15346
 DESCRIPTION: Res
 CONTRACTOR: Bandal Coat #10734
 ADDRESS: 12 Cragmoor Village Rd
 Plot plan Sets of Plans
 Permit Number D16087 Zone _____ City _____ County _____
 APPROVED FOR CONSTRUCTION
 Date 4/19/00 Issued _____ By AN

PATTERSON SUBDIVISION
 HILLSIDE DEVELOPMENT/SITE PLAN
 PROJECT NO. 99124
 Drawn By: RDG
 Checked By: DVH
 Date: 10/11/99
 Sheet: 2 of 2

RE: City File Number: AR DP 00-063 & AR S 00-064F: Patterson Subdivision

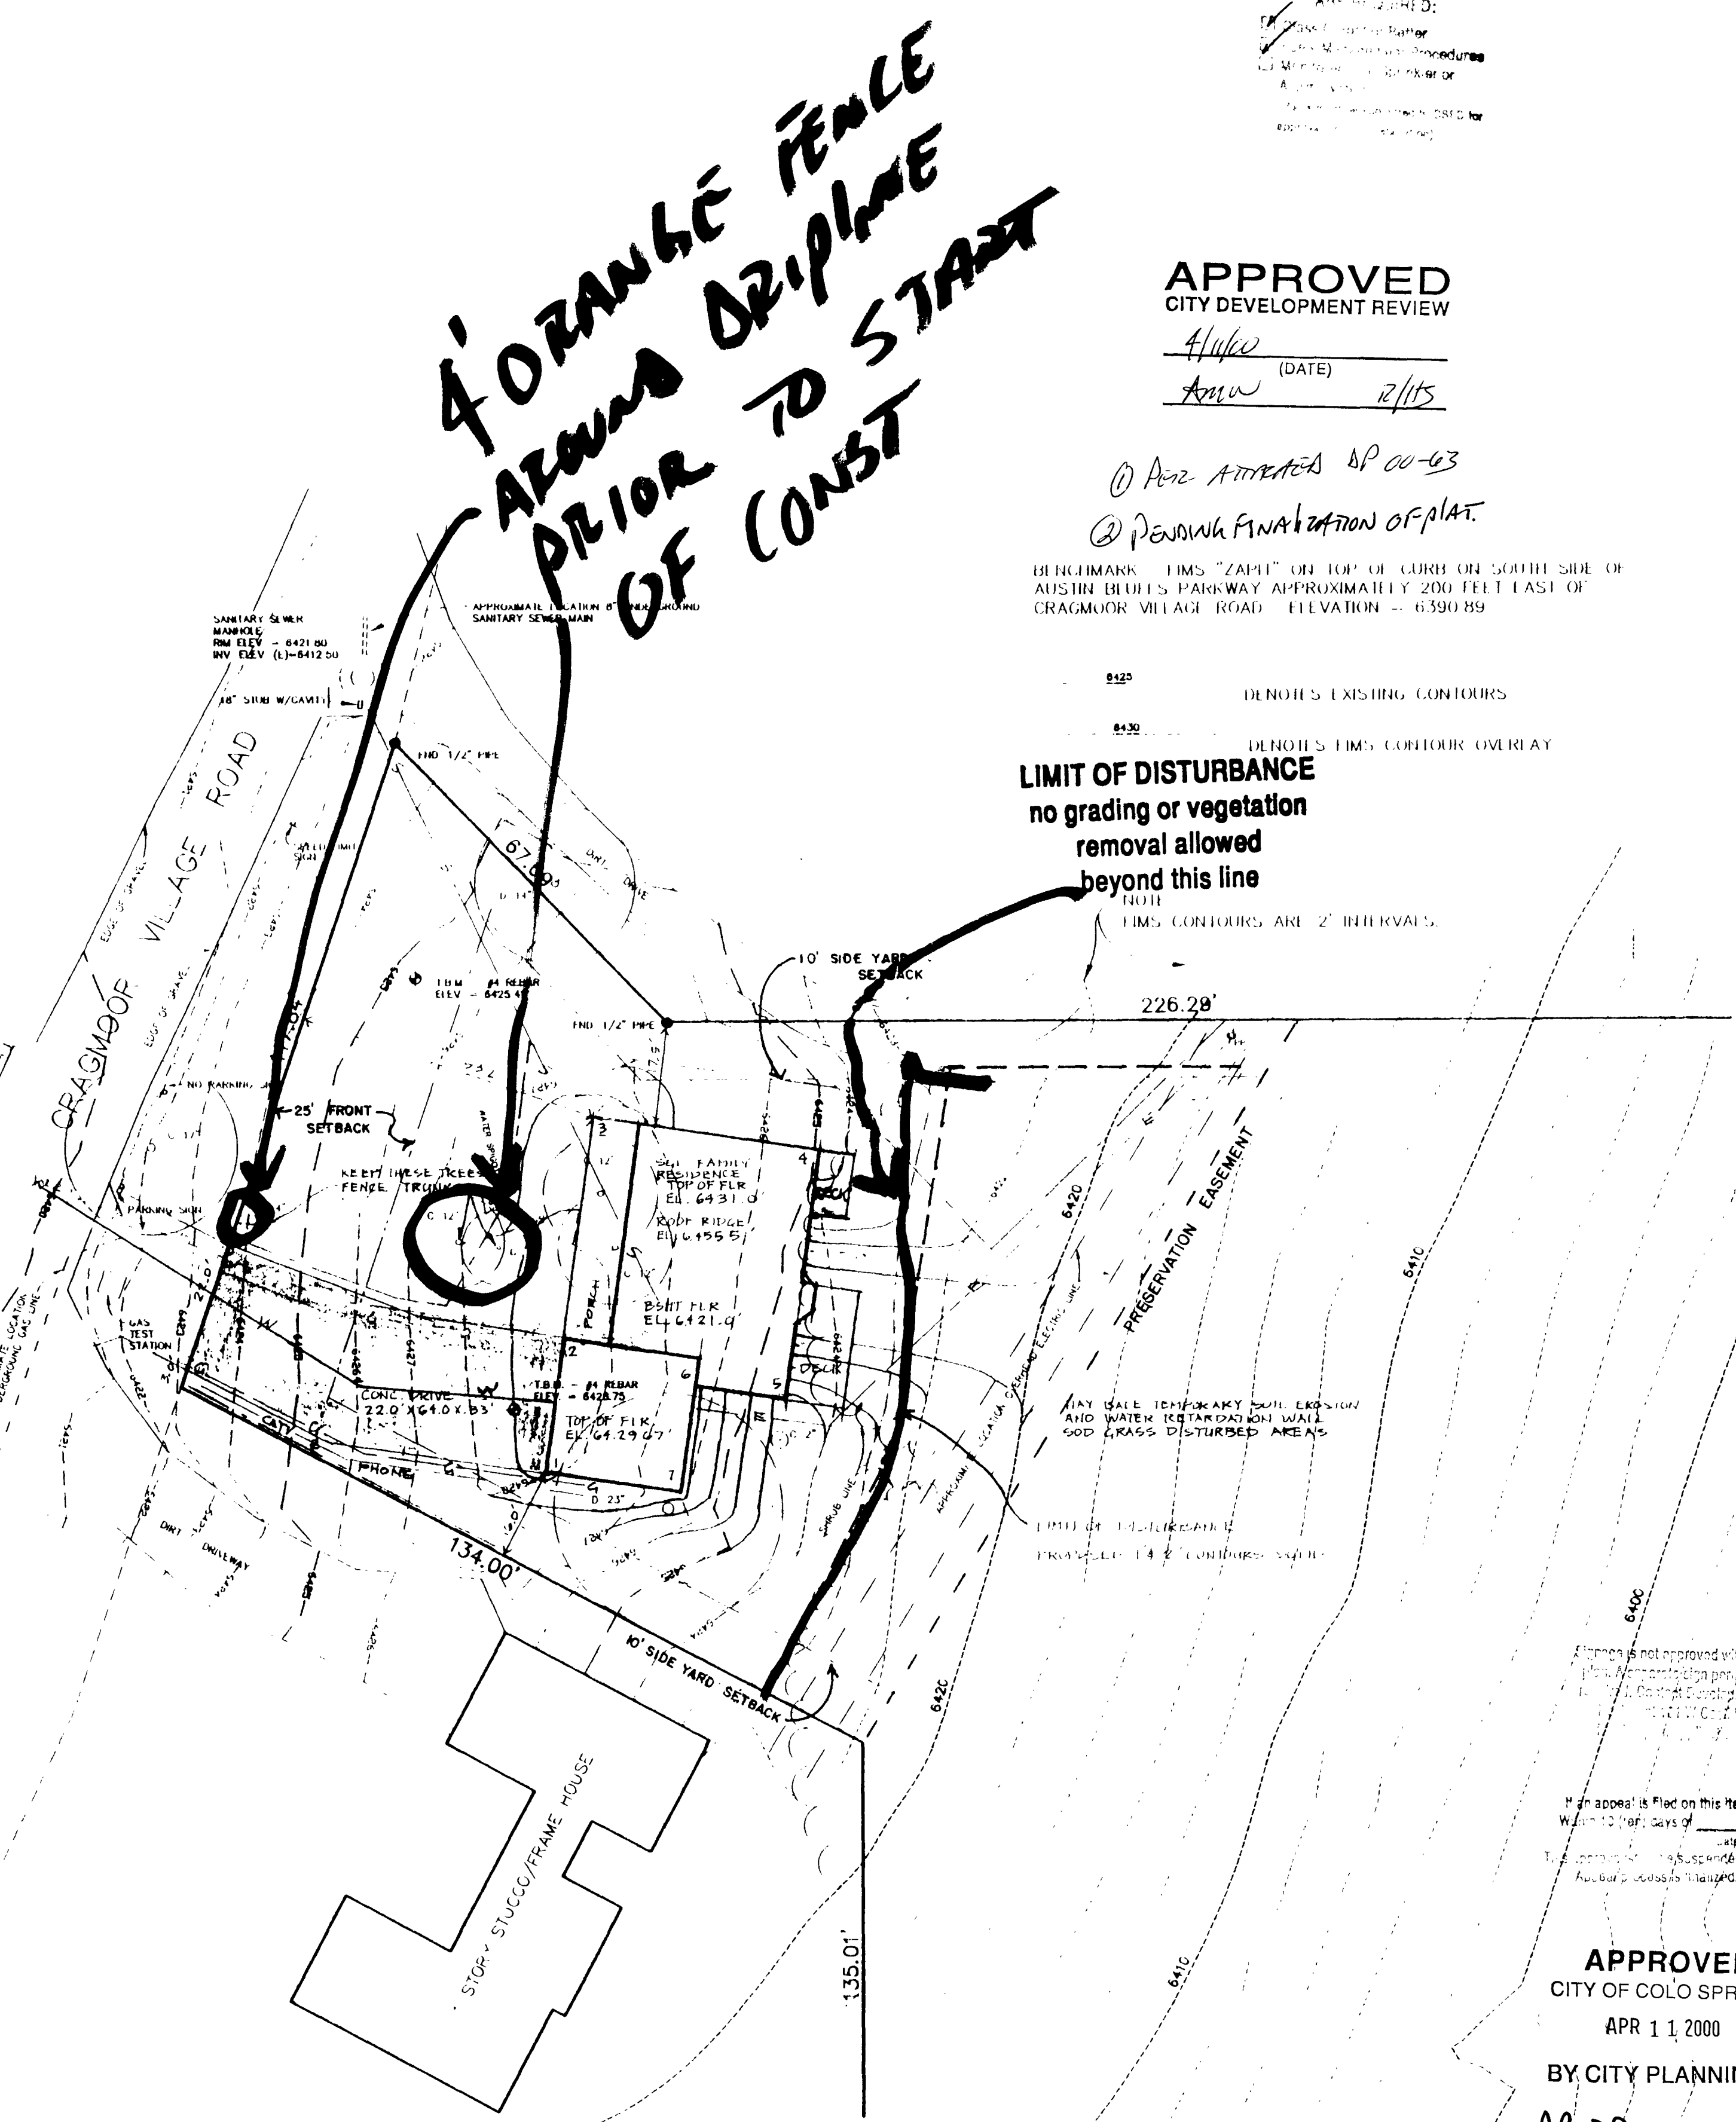
MINIMUM DETAIL DRAW PENDING FINALIZATION OF PLAT PER DP 00-63 SEE LIMITS OF DISTURBANCE ON SITE PLAN
 Attach Approved (Stamped) Development Plan With Resubmittal
 RECORDED
 SHOW PROOF OF LEGAL LOT OR ATTACH COPY OF RECORDED PLAT

RELOCATE EXISTING GAS TEST STATION AND PARKING SIGN IF REQUIRED.
 EQUIPMENT MATERIAL AND SOIL STORAGE SHALL BE IN DRIVEWAY AREA.

- 1) PER APPROVED DP 00-063
- 2) PENDING FINALIZATION OF PLAN
